APPLICATION NO.	FILING DATE	FIRST NAMED INVENTOR	ATTORNEY DOCKET NO.	CONFIRMATION NO.
09/822,126	03/30/2001	Hassan A. Serhan	DEP0546	8872
7590 01/09/2006			EXAMINER	
Philip S. Johnson Johnson & Johnson One Johnson & Johnson Plaza New Brunswick, NJ 08933			MANAHAN, TODD E	
			ART UNIT	PAPER NUMBER
			3732

Office Action Summary	Application No.	Applicant(s)	
	09/822,126	SERHAN ET AL.	
	Examiner	Art Unit	
	Todd E. Manahan	3732

DETAILED ACTION

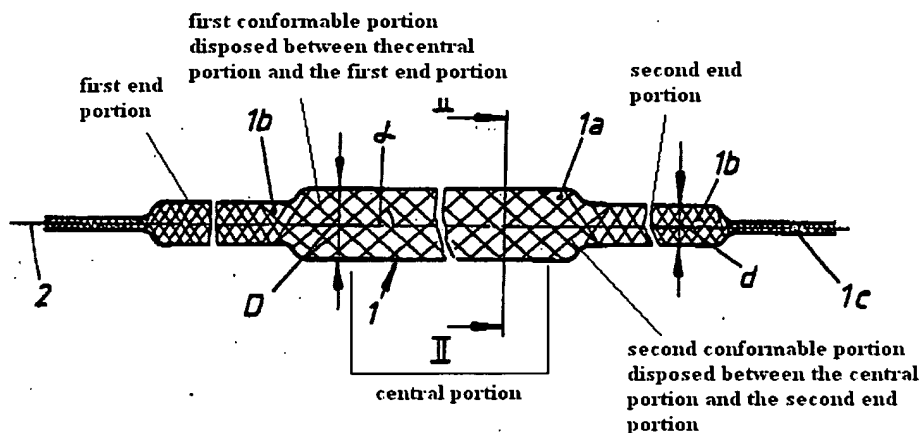
Mansat discloses a connection system comprising a ligament and first and second bone fasteners. The ligament is made of a braided fabric and includes a central portion, first and second end portions and first and second conformable portions disposed between the end portions and the central portion. The fasteners may be shoulderless. Regarding claim 1, for applicant's convenience, figure 1 has been reproduced below with the claimed element clearly marked:

Fig.3

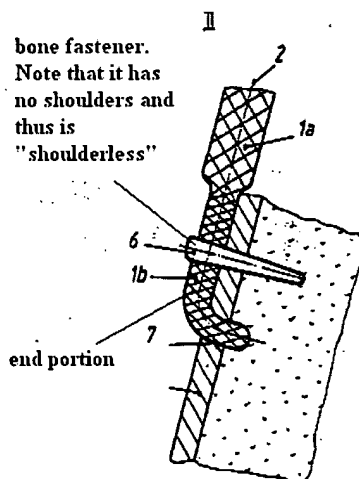
Regarding the bone fasteners, for applicant's convenience, figure 3 has been reproduced below with the claimed elements clearly marked. It is to be understood that while only one end portion is shown in the figure both the first and second end portions are identical:

Note that the shape of the end portions is such that they cooperate to connect with the bone fasteners. The claim requires nothing more. Regarding claim 5, see column 3, lines 55-57 which state that the device can be placed under a tensile loading, i.e. it is "tensionable". Regarding

FIG. 1

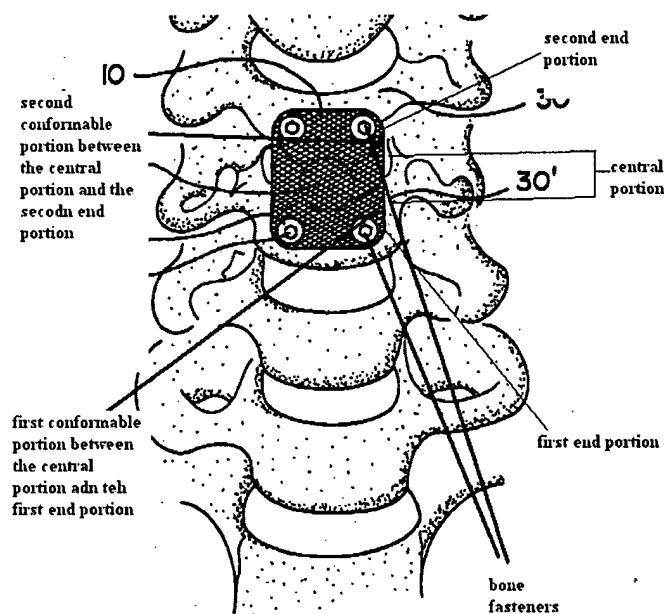
Yuan et al. disclose an intervertebral connection system comprising a ligament 10 and first and second bone fasteners 20 as clearly seen in figure 1 and as set forth in column 2, line 65 through column 3, line 31. The ligament is made of a fabric such as DACRON, see column 1, lines 61-63, and includes a central portion, first and second end portions and first and second conformable portions disposed between the end portions and the central portion. It is noted that the mat is flexible, see column 1, line 64, and thus all the portions would be “conformable.” Regarding claim 1, for applicant’s convenience, figure 1 has been reproduced below with the claimed element clearly marked:

The end portions have a shape such that they cooperatively connect with the bone fasteners, i.e. via a hole. The fasteners may be shoulderless (see figure 5). Regarding claims 5 and 7, see column 1, line 65 which states that the device may be woven. It is noted that woven DACRON can be placed under tension, i.e. “tensionable”. Regarding claim 6, see column 3, lines 35 and
